# A comment on the HumeLink Submissions Report and revised Biodiversity Development Assessment Report – part 2: failure to avoid or mitigate biodiversity impacts

HumeLink Alliance Incorporated  
August 19, 2024

**Figure 1: GHD Option 2A-1 HVDC cable system conceptual design**

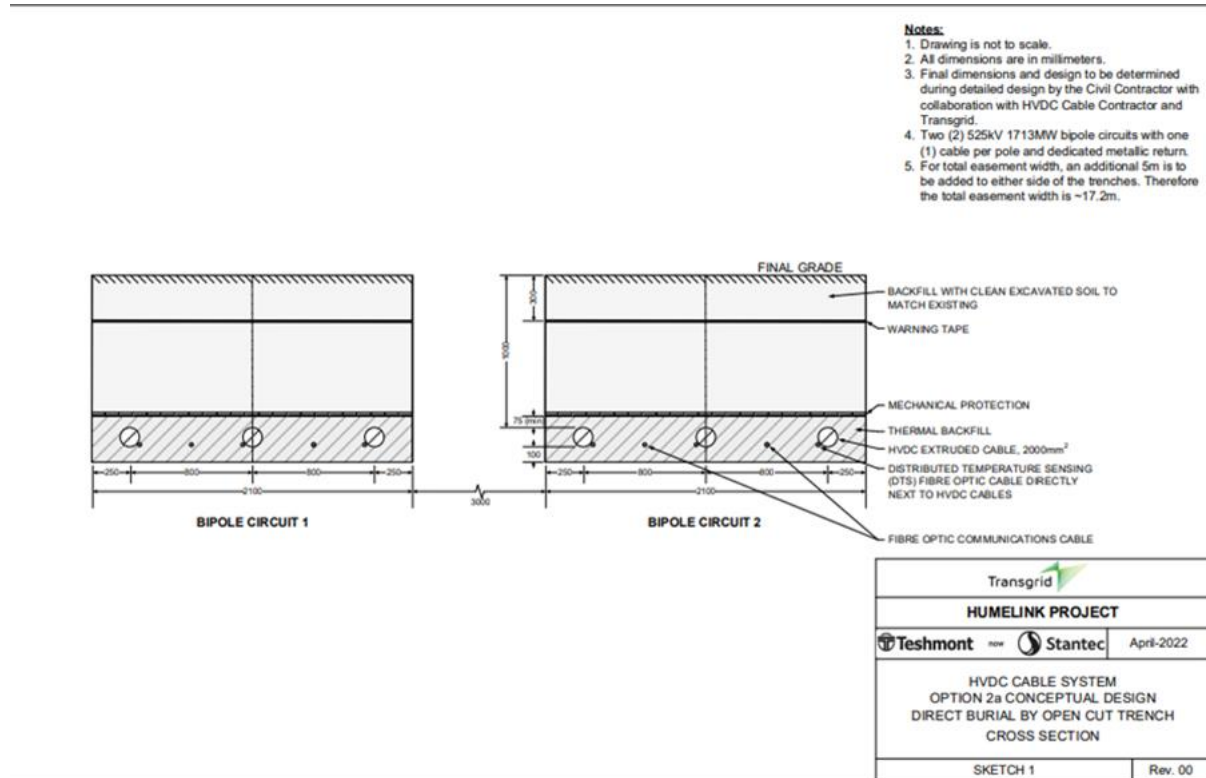
The easement width of underground “Option 2A-1” in the GHD study is 17.2 m compared with 70 m for overhead (2 x 2.1 m + 3 m + 2 x 5 m = 17.2 m), see Figure 1 below.<sup>10</sup> The biodiversity offset costs reported for the underground GHD Option 2A-1 were \$363 million, 50% less than the overhead option (see Appendix A).

Note also that a 50% reduction in biodiversity offsets for underground transmission is likely an underestimate, and the true savings in biodiversity offset costs could be as much as 75% (i.e. 17.2 m is 75% narrower than a 70 m transmission easement).<sup>11</sup>

**Figure 5 – Cable Trench Profile**

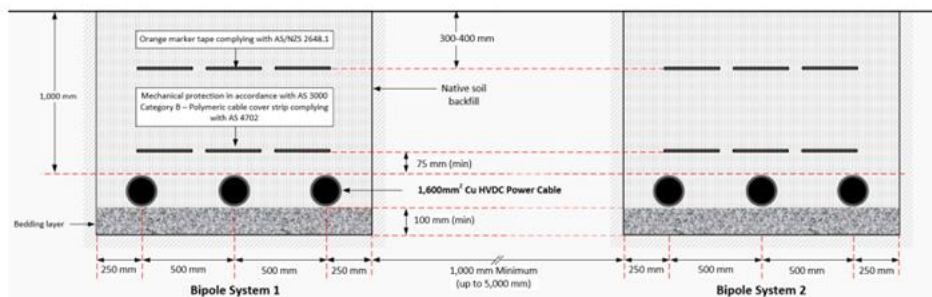
The undergrounding solution in the Amplitude Review<sup>12</sup>, the 'Amplitude Modified Option 2A-1', has a minimum width of 4 m wide ( $2 \times 1.5\text{m} + 1\text{m} = 4\text{m}$ ), see Figure 5 below.

The easement width of 'Amplitude Modified Option 2A-1' at 4 m is 94% narrower than the overhead option at 70m. Therefore, the biodiversity costs can potentially be reduced 94% with undergrounding on the basis of easement width.
